## 5.0 Viaduct Arches (Building V)

### 5.8 Revised Scheme-

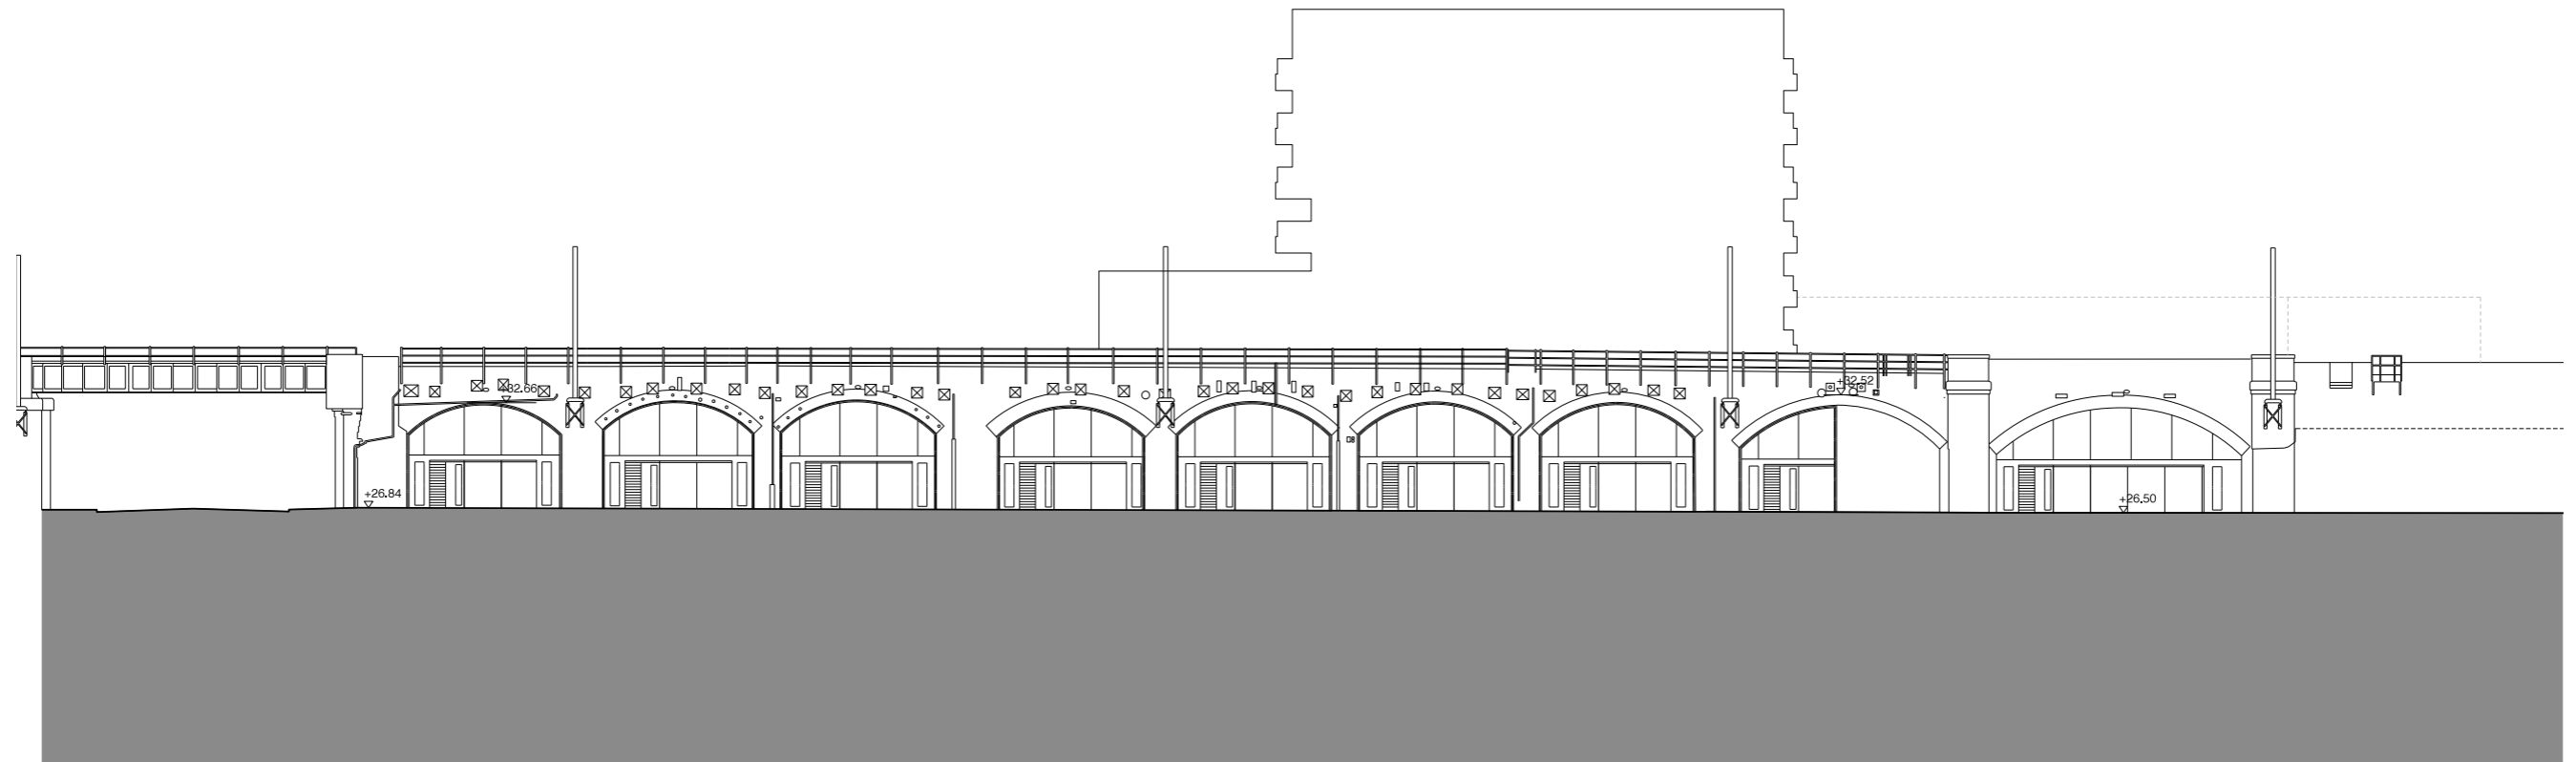
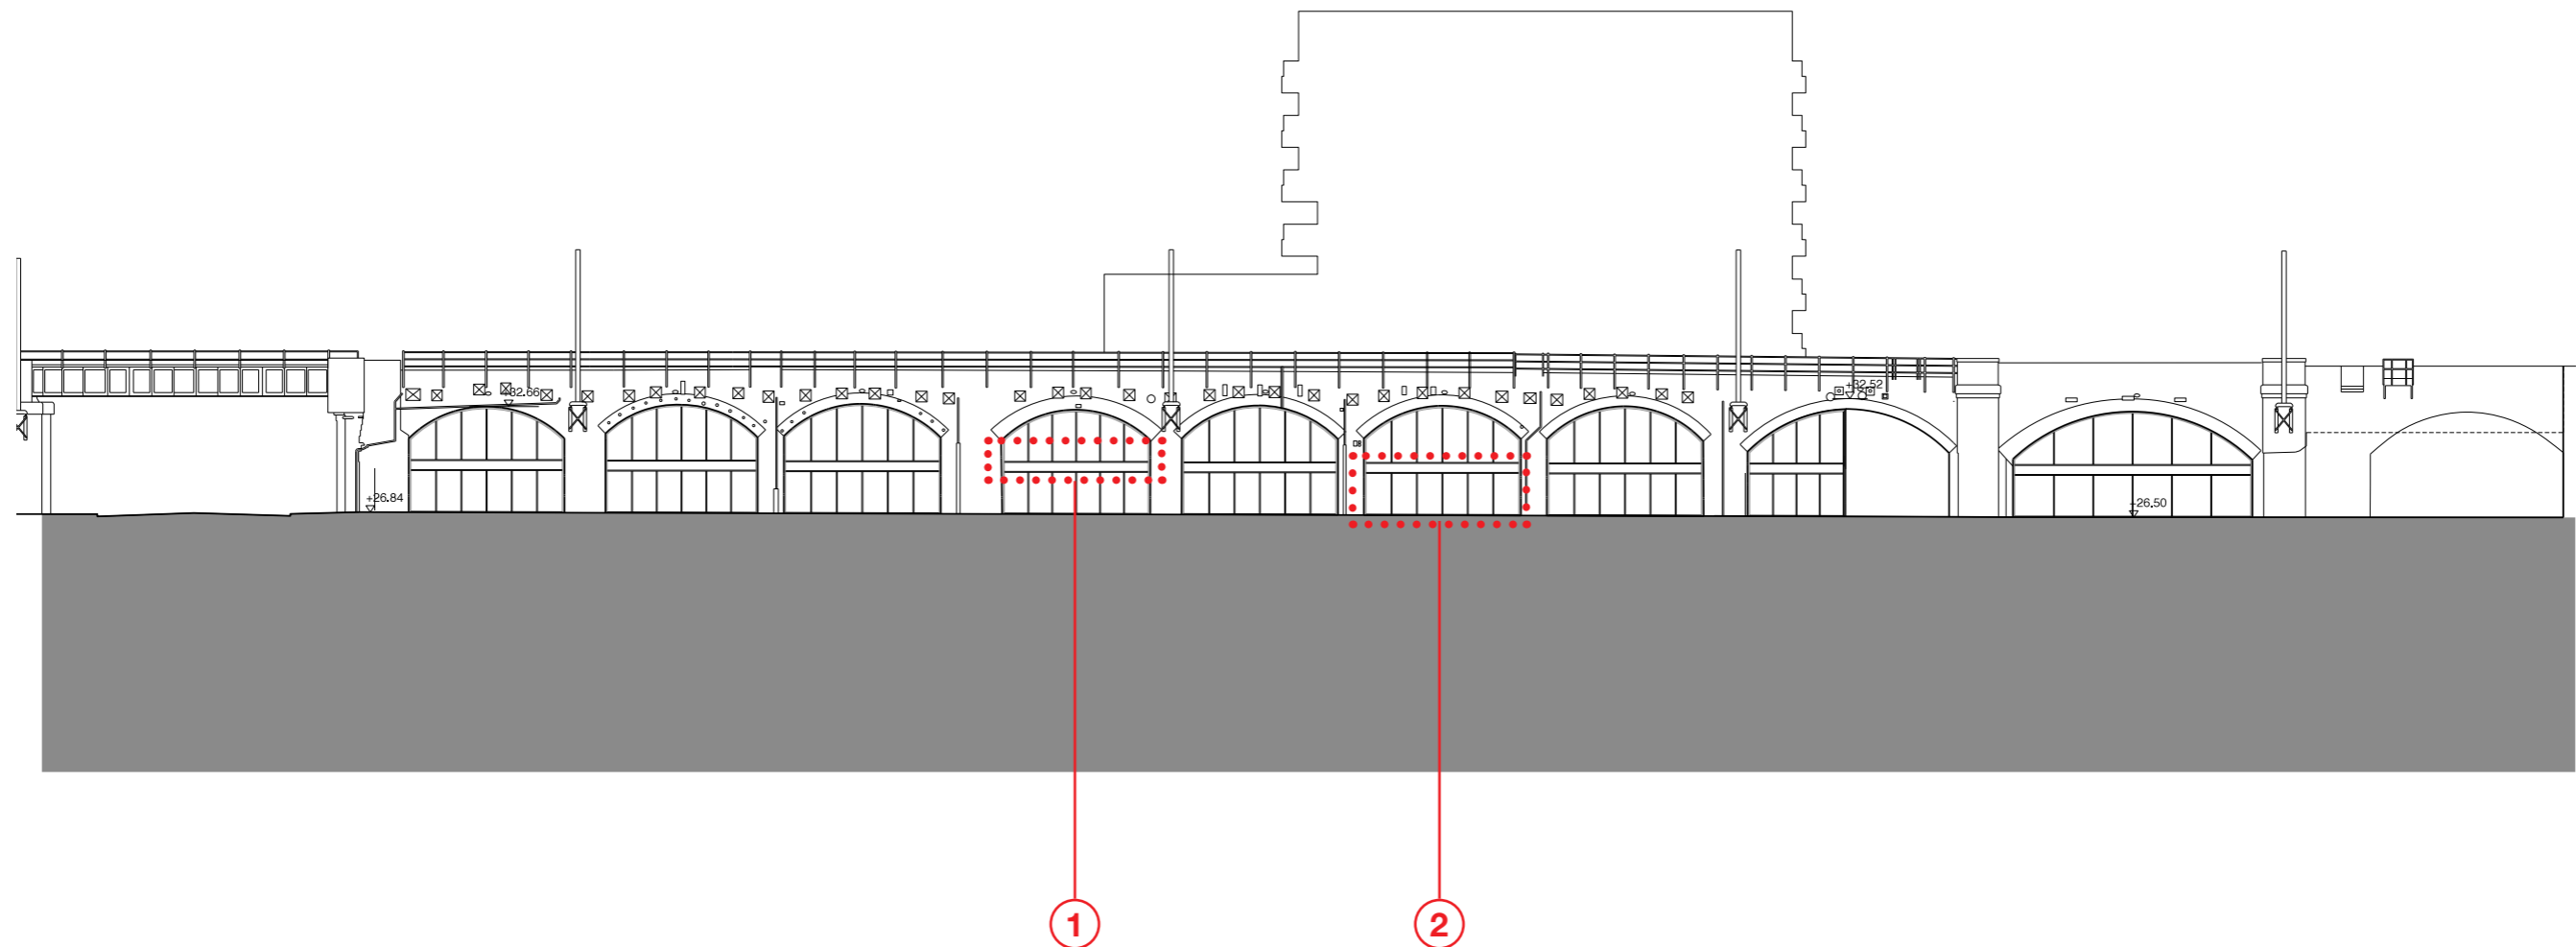
- ① Panels incorporating signage and ventilation zone
- ② Removal of louvres on ground floor entrance elevation

### 5.10 Revised Scheme - Area B Arches

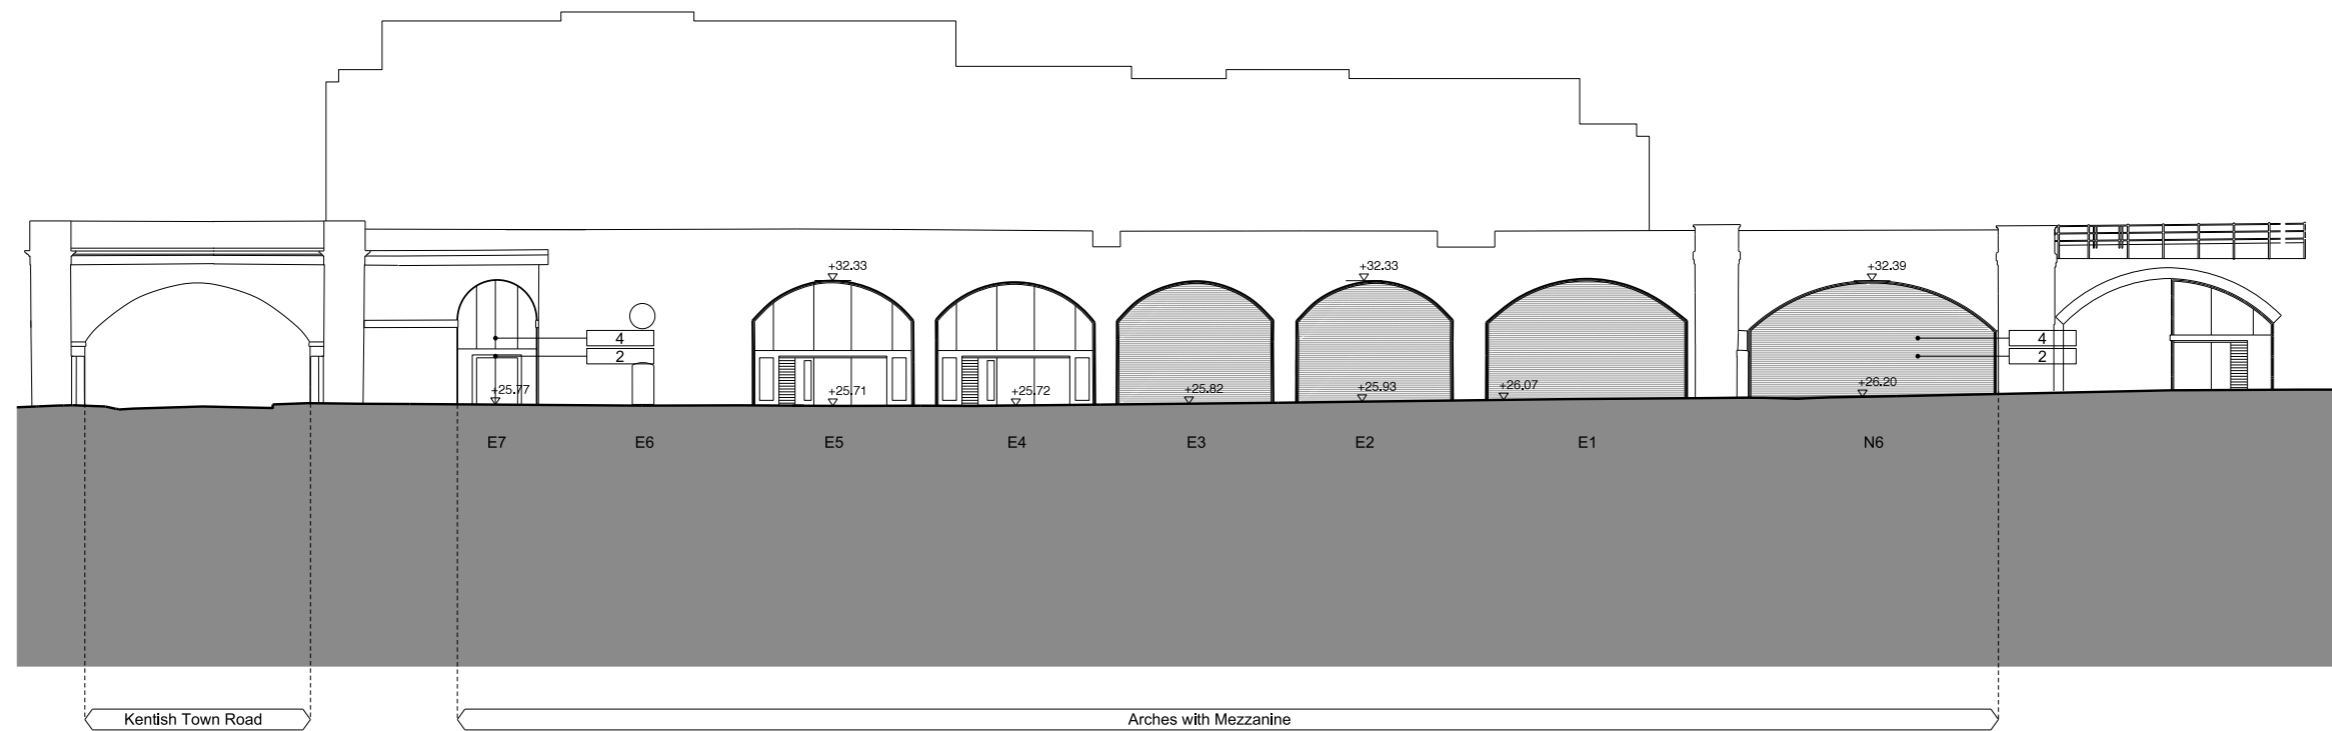
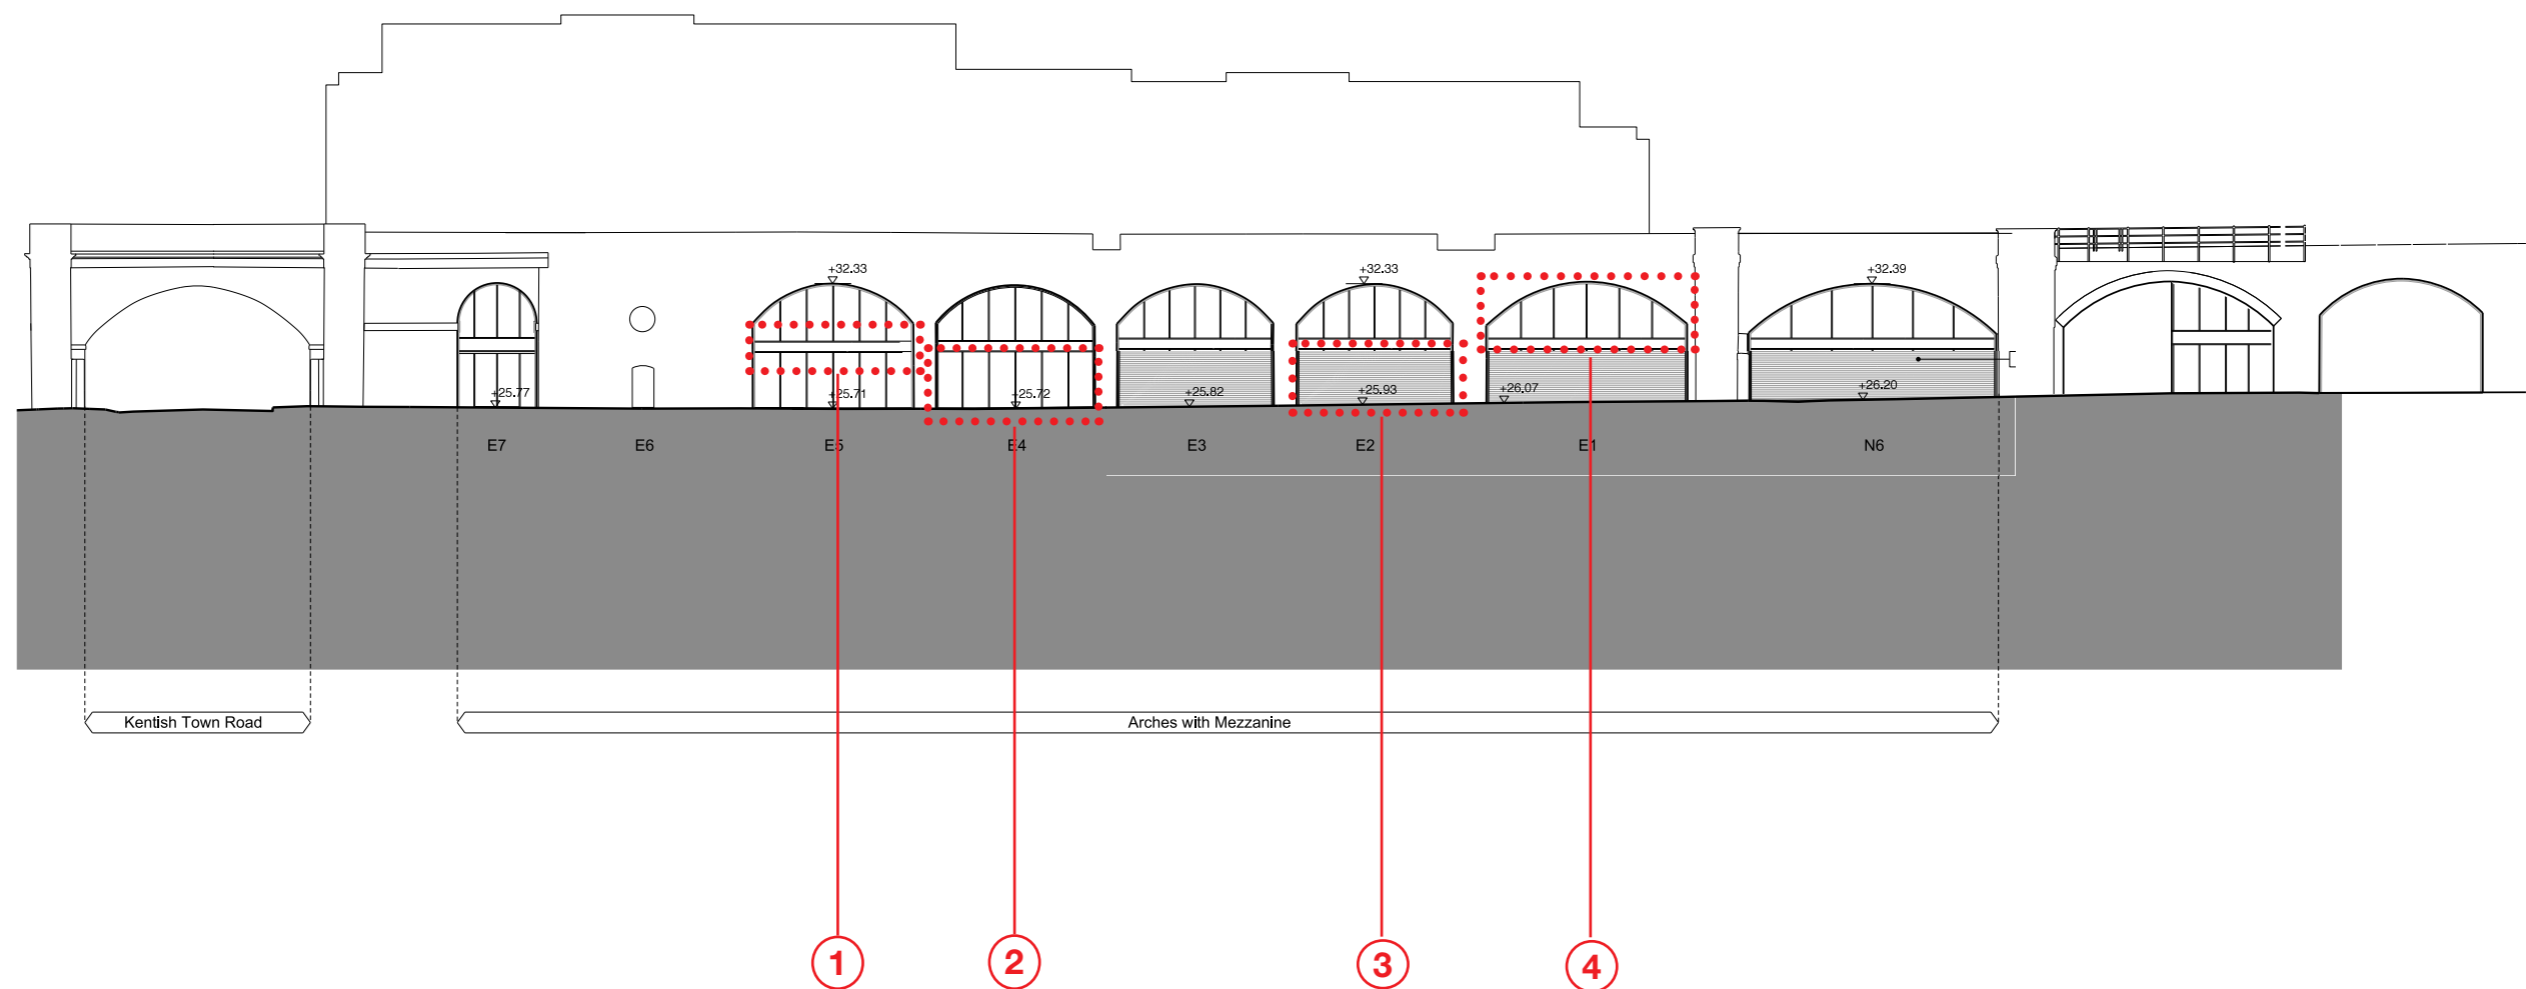
| ① Panels incorporating signage and ventilation zone | ③ Brick wall                          |
| ② Potential full-width opening entrance on facade   | ④ Curtain wall system. Obscured glass |
